Access Compliance Report

Public Rights-of-Way

(Curb Ramps)

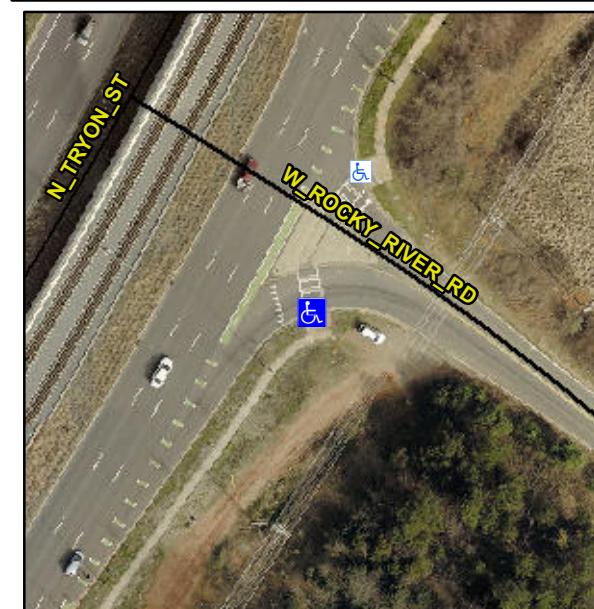
Intersection ID: 6611	Main Street: N_TRYON_ST	Cross Street: W_ROCKY_RIVER_RD	Location: S
ADA ID: EFFF03C05E3B	Ramp Type: Perp	Initial Pass/Fail: Fail	Overall Compliance: No
Severity Score: 12.5			
Codes/Mitigation Info/Possible Solution		Field Measurements/Component Compliance

Not Found, R304.2.2

Compliance	Description	Data	Compliance	Description	Data
N/A	Ramp Length (in)	96.0	No	Ramp Slope (%)	9.4
Yes	Ramp Width (in)	48.0	Yes	Ramp XSlope (%)	0.1
N/A	Flare Type LT	N/A	N/A	Flare Type RT	N/A
N/A	Flare Slope LT (%)	N/A	N/A	Flare Slope RT (%)	N/A
N/A	Flare Traversable LT?	N/A	N/A	Flare Traversable RT?	N/A
N/A	Landing Length (in)	N/A	N/A	DWS Provided?	N/A
N/A	Landing Width (in)	N/A	N/A	DWS Contrast?	N/A
N/A	Landing Slope (%)	N/A	N/A	DWS Length (in)	N/A
N/A	Landing X Slope (%)	N/A	N/A	DWS Full Width?	N/A
N/A	Landing Curb? (Y/N)	N/A	N/A	DWS Offset (in)	N/A
N/A	Shared Landing?	N/A			
N/A	Gutter Ponding?	N/A	N/A	Gutter Slope (%)	N/A
N/A	Gutter Lip Ht (in)	N/A	N/A	Gutter X Slope (%)	N/A
N/A	Painted X Walk1?	Yes	N/A	Painted X Walk2?	N/A
	X Walk 1 Direction	To NE		X Walk 2 Direction	N/A
N/A	X Walk 1 Width (in)	114.5	N/A	X Walk 2 Width (in)	N/A
	X Walk 1 Slope (%)	0.1		X Walk 2 Slope (%)	N/A
	X Walk 1 X Slope (%)	0.6		X Walk 2 X Slope (%)	N/A

Remove & Replace Entire Ramp.
